Written submission from Northwatch

Application from the CNL to amend its Chalk River Laboratories site licence to authorize the construction of a near surface disposal facility

2022-H-07

Presentation slides for Northwatch,
Radioactive Waste Management
Associates and Hutchinson
Environmental Science Inc.

Communication Uncertainties – Intermediate-Level Radioactive Waste Acceptance

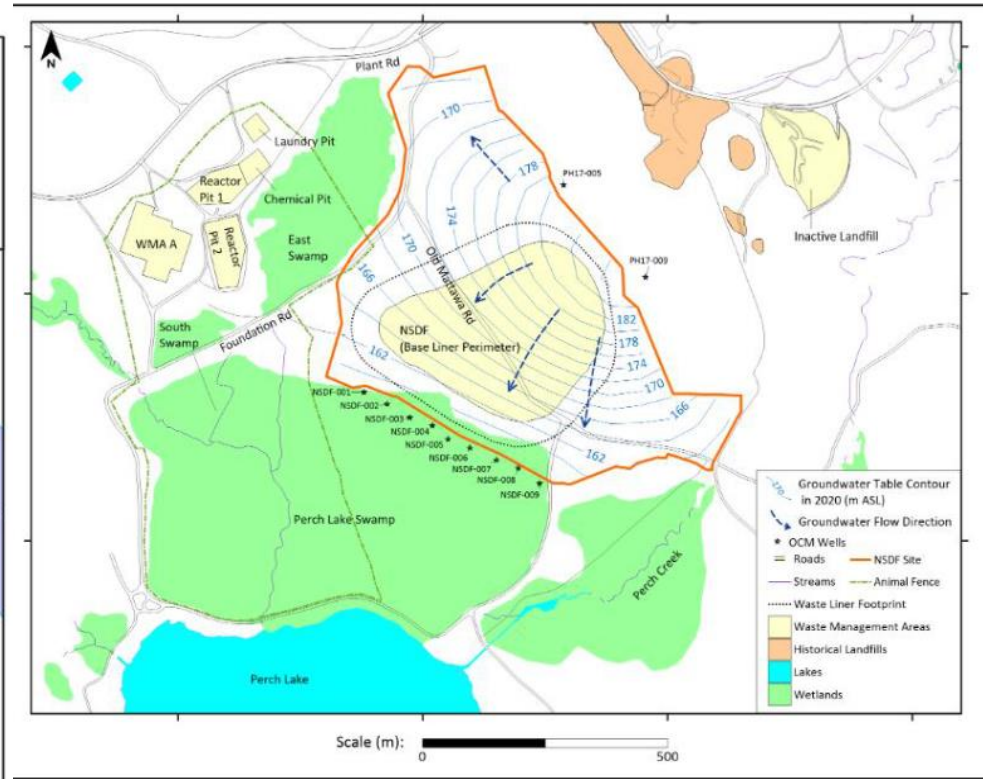
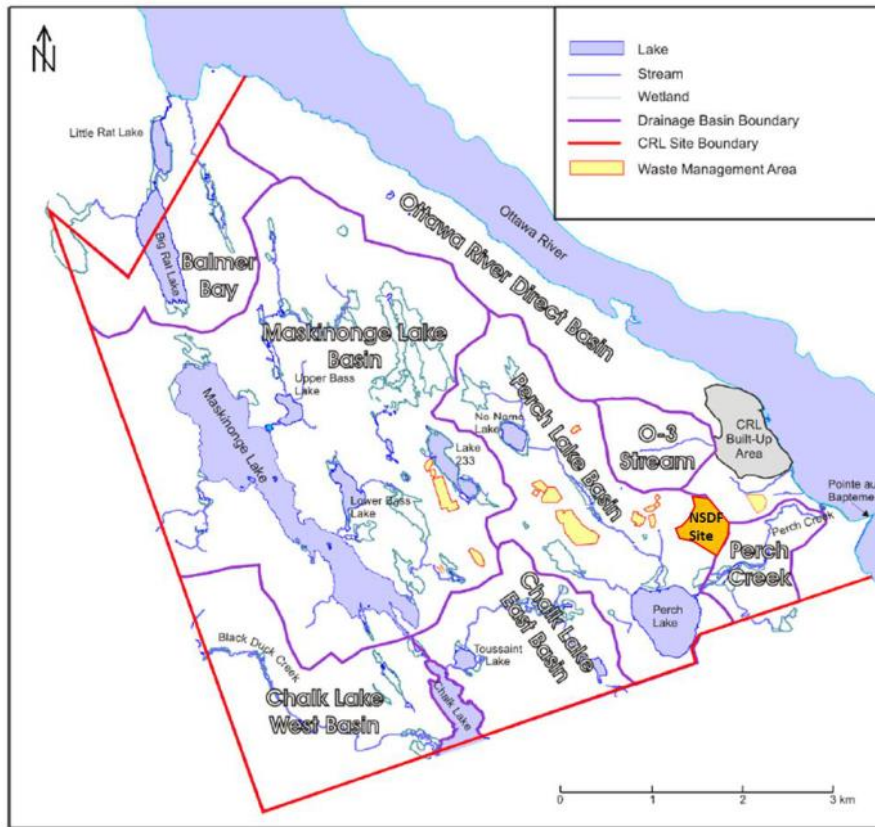
- Some confusion surrounding the types and quantities of intermediate-level radioactive waste that are acceptable in the NSDF
 - Provisions made for inclusion of intermediate-level waste if separating longer-lived radionuclides from legacy waste is not feasible.
 - In the EIS, 87% of accepted waste volume will be bulk materials, 13% packaged waste. In CNSC document, ~90% of waste is contaminated soils and building materials.
 - The acceptable amount of intermediate-level radioactive waste should be further defined to prevent unacceptable quantities/types from being deposited.
- The number and volume of long-lived radionuclides (half-life >30 years) that will be accepted for disposal is not well understood.

Impacts to Potential Receivers

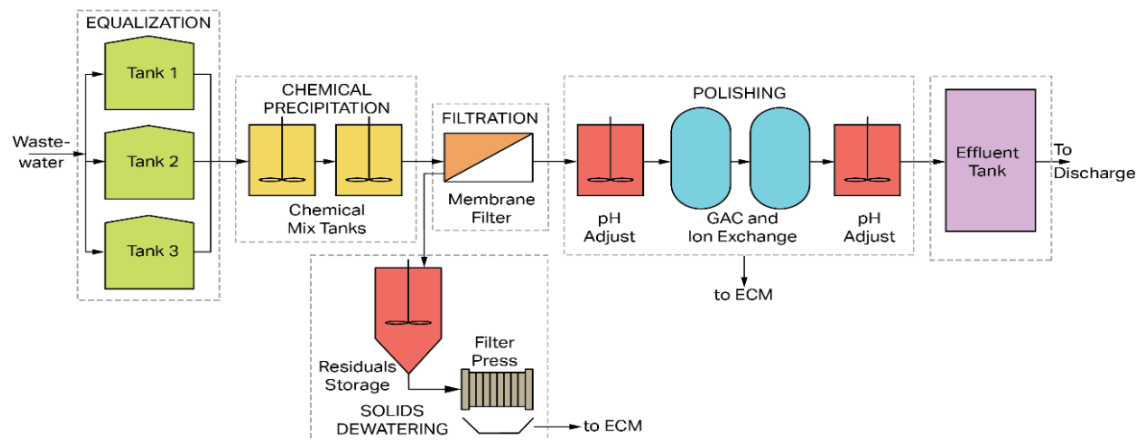
Potential environmental impacts and framework for detecting project-related effects were not well understood from the core documents

- Reference/summary of guidelines and mitigation strategies should be available in licensing documents to increase public confidence

National Nuclear Security Site, Nevada

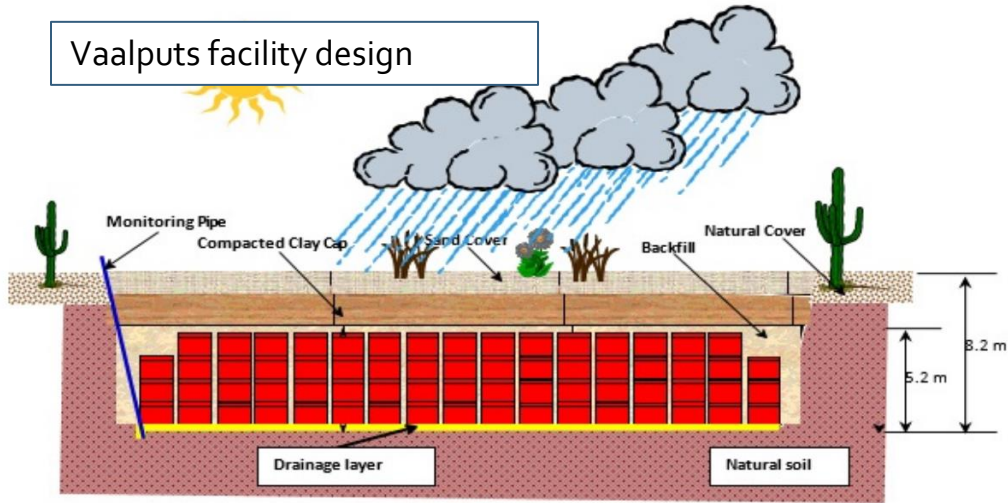
- NSDF waste acceptance criteria compared to 4 international facilities:
 - National Nuclear Security Site, Nevada, USA
 - Lillyhall Landfill, Cumbria, UK
 - Paducah Gaseous Diffusion Plant, Kentucky, USA
 - Vaalputs facility, South Africa
- Considerations for particle and radionuclide resuspension
- Groundwater velocity – not provided in NSDF WAC
- Leak detection protocols – not encountered

CNSC, 2022. Written submission from Canadian Nuclear Laboratories, Commission Public Hearing Part 1, February 22, 2022 (CMD22-H7-1). Figure 19: Cross-Section of Engineered Containment Mound.

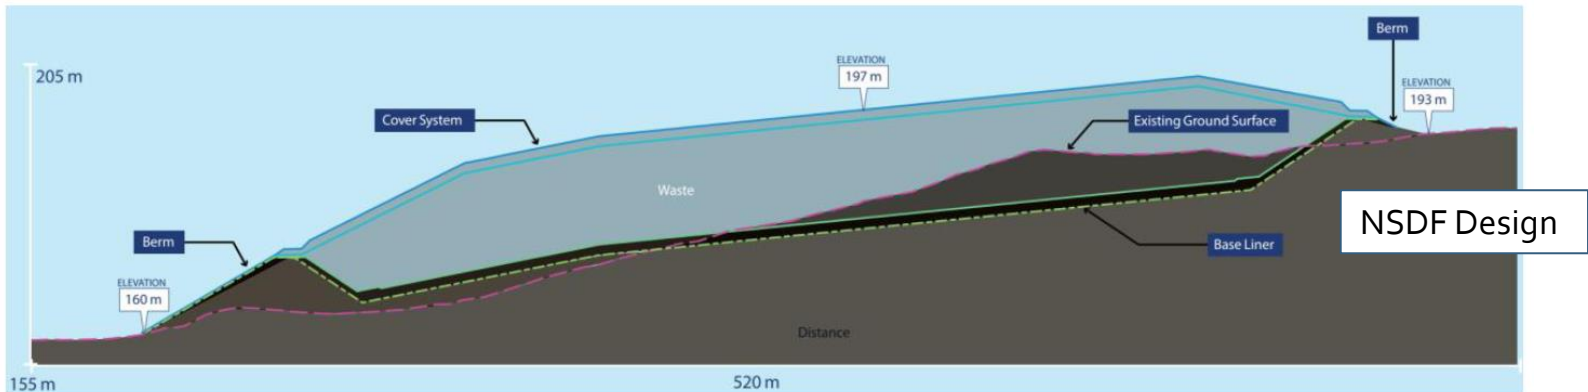
- No provisions made for intermediate-level radioactive waste in other international facilities– NSDF may have a more robust construction
